# PLANNING COMMISSION REPORT Regular Agenda – Non-Public Hearing Item

PC Staff Report 08/24/09

## ITEM NO. 3 PRELIMINARY PLAT FOR PARK PLACE ADDITION FRONTIER ROAD & FIRESIDE DRIVE (SLD)

**PP-6-3-09**: Consider a one lot multi-family Preliminary Plat on 7.716 acres for Park Place Addition, a replat of Boardwalk Addition, Lots 1-3, located at 510-544 Fireside Drive. Submitted by Paul Werner Architects, for Ernest Fleischer, property owner of record.

Existing Platted Area and Proposed Right-of-Way Vacation of Fireside Drive.

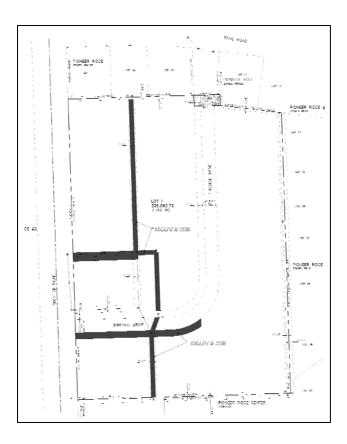
The proposed preliminary plat will vacate a section of remaining right-of-way for Fireside Drive. The proposed vacation abuts a parcel located on the south east corner of Fireside Drive and Trail Road. This parcel is under the same ownership as the proposed plat. Vacation of the right of way will not alter the lot configuration of the parcel located on the corner (3213 A and B Trail Road) but will be added into the new parcel dimensions for the apartment complex.

Access to the new lot is accommodated at Frontier Road and the remaining street stub that is Fireside Drive. This provides secondary access for the development to a public street. The proposed plat shows that a 30' access easement will be retained throughout the development centered on the original street center line of Fireside Drive.

The vacated Fireside Drive is designated as a public access easement. As such, this access easement cannot be gated to restrict vehicular or pedestrian access to the development. This prohibition should be reflected with a note on the face of the plat.

The plat further shows and notes existing utility easements that are intended to be vacated, retained and new easement to accommodate the future redevelopment of the site.

1. Provision of a revised preliminary plat to include a note that states "public access shall not be gated in any way to prevent vehicle or pedestrian access to the property or development."
